CONSTRUCTION SUMMARY

Summer Ridge Estates Inc.

LOT NUMBER	PHASE	HOUSE TYPE	CLOSING DATE
023 BLOCK 292	1	DESERT ROSE (25-01-A2) ELEV A2	04-Feb-26

BLOCK 292 - TH 23 25-01 DESERT ROSE EL. A2 3 BEDROOM 2045 SQ. FT.

LOWER LEVEL
ELEV. A2

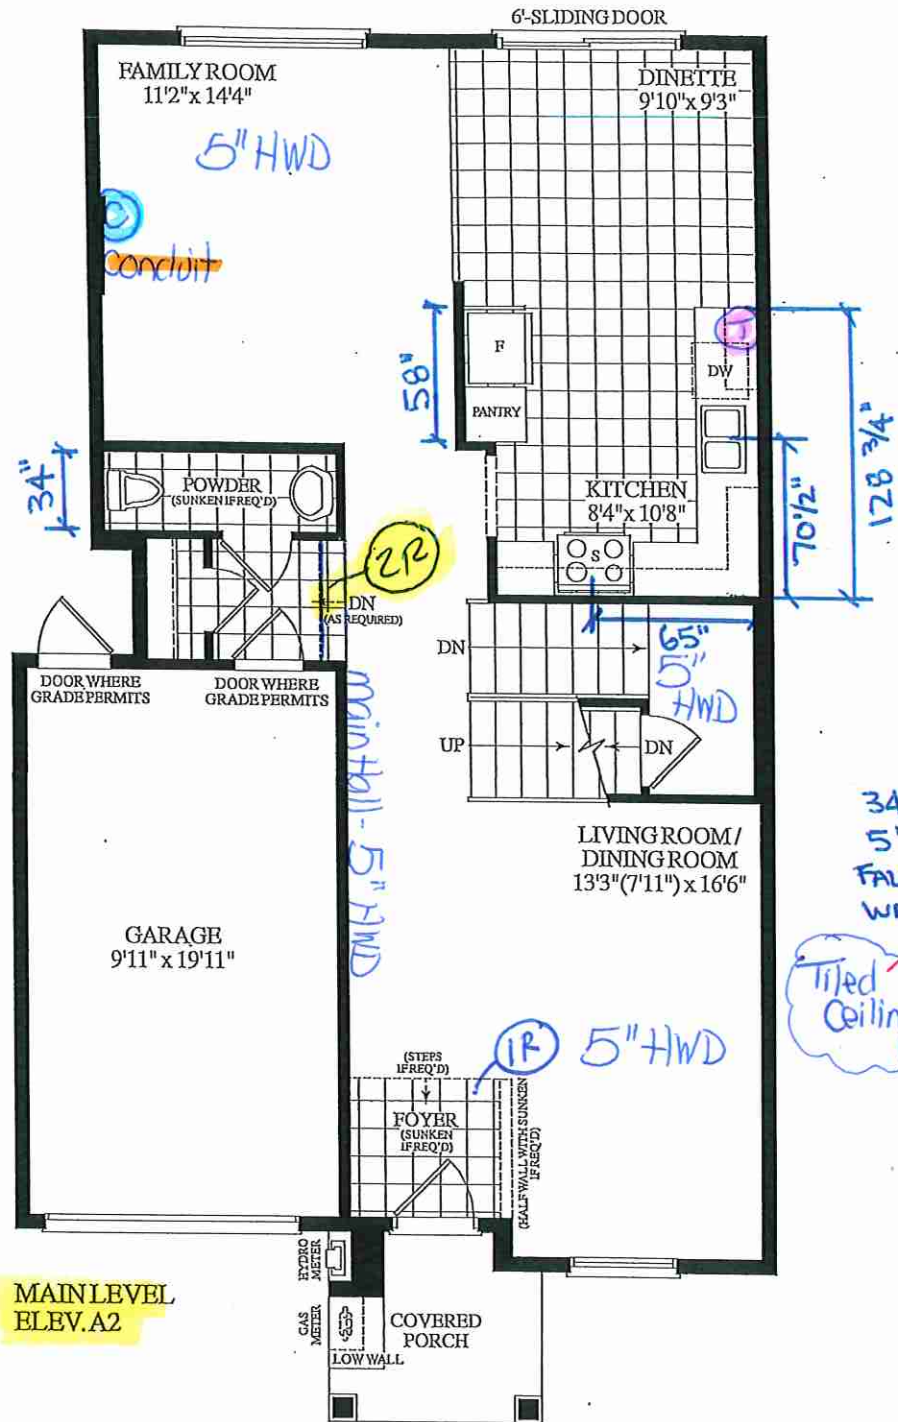
1 - BASEMENT - Install UPGRADE 200 AMP SERVICE in lieu of builders standard 100 Amp service (See Sketch)

MAIN LEVEL
ELEV. A2

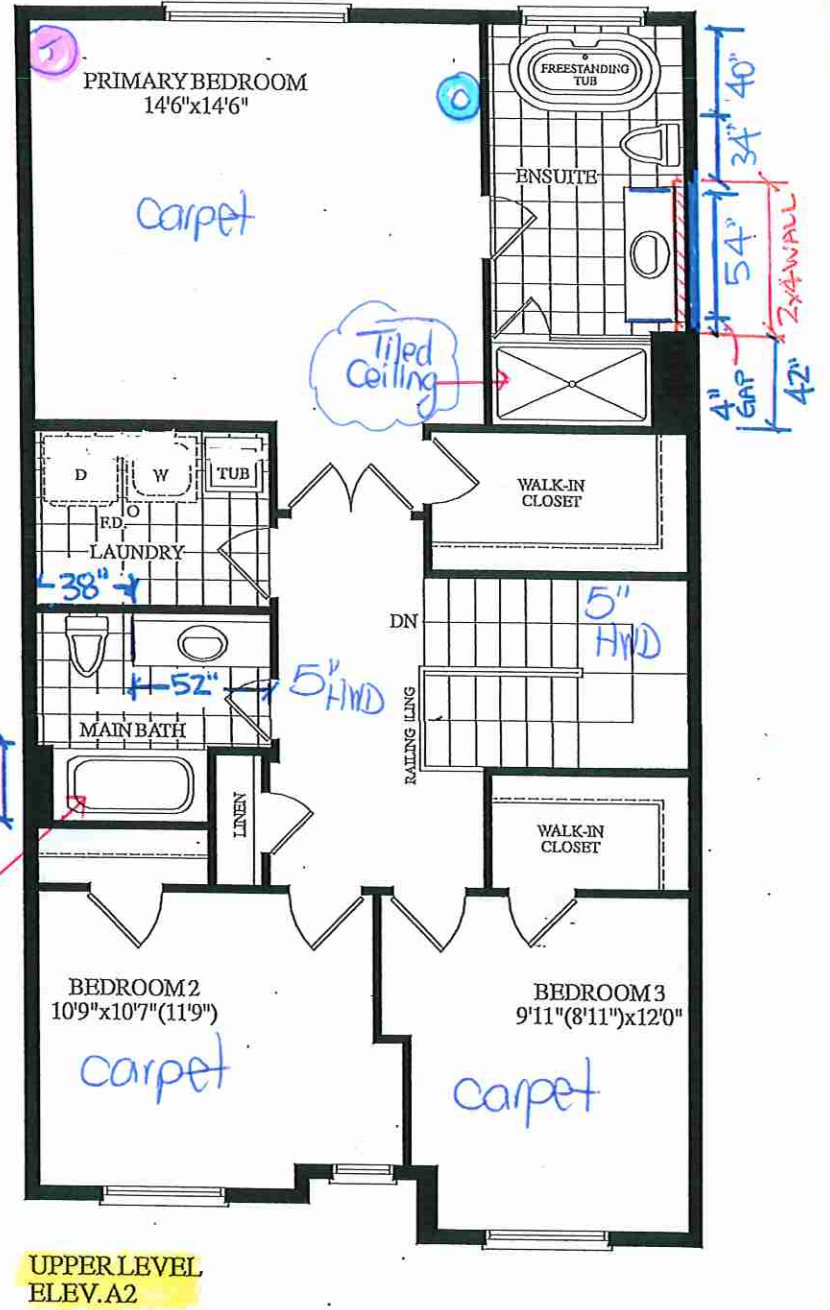
1 - MAIN FLOOR & UPPER HALL - FLOORING - HARDWOOD - Install prefinished 5" x 3/4" VINTAGE WHITE OAK BAROQUE (Character Pearl) in lieu of builders standard prefinished 3 1/4" x 3/4" Vintage Red Oak Natural Hardwood.

Note: To be installed throughout main floor and upper hall, where applicable. To Include; LivingRoom/DiningRoom, Main Hall, Family Room, Upper Hall and Applicable Landings (See Sketch)

1 - STAIRCASE - Stain Oak Staircase from Main Floor to Second Floor, where applicable. To be Stained - Vintage Red Oak BAROQUE - To Include; Treads, Risers, Handrail and Post, where applicable (See Sketch)

EDGE
DETAILS

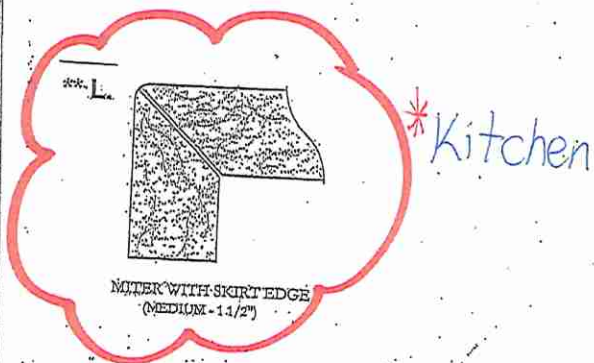
1 - KITCHEN - COUNTERTOP EDGE - Install UPGRADE " L " EDGE PROFILE - To be installed throughout kitchen countertop, where applicable (See Sketch)

KITCHEN PLAN

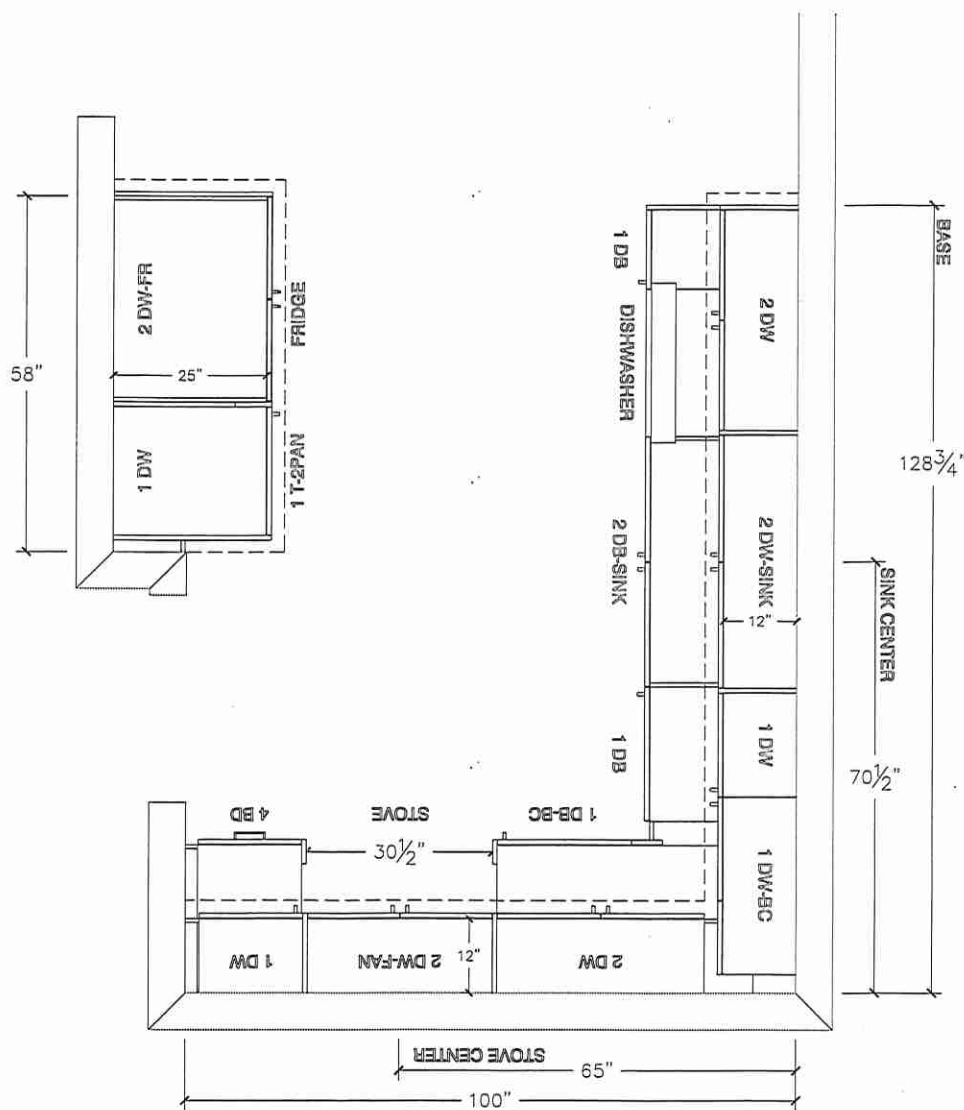
1 - KITCHEN & BATHROOMS - Purchaser has DECLINED All Upgrades offered during decor appointment at the decor centre for kitchen & bathroom cabinetry. Standard Kitchen Layout & Standard Bathroom Vanities to be installed as per standard plan. (See Sketch)

1 - KITCHEN - COUNTERTOP - Install UPGRADE #2 Stone Countertop – EVEREST WHITE SHIMMER - To be installed throughout kitchen, where applicable (does not include stone backsplash) (See Sketch)
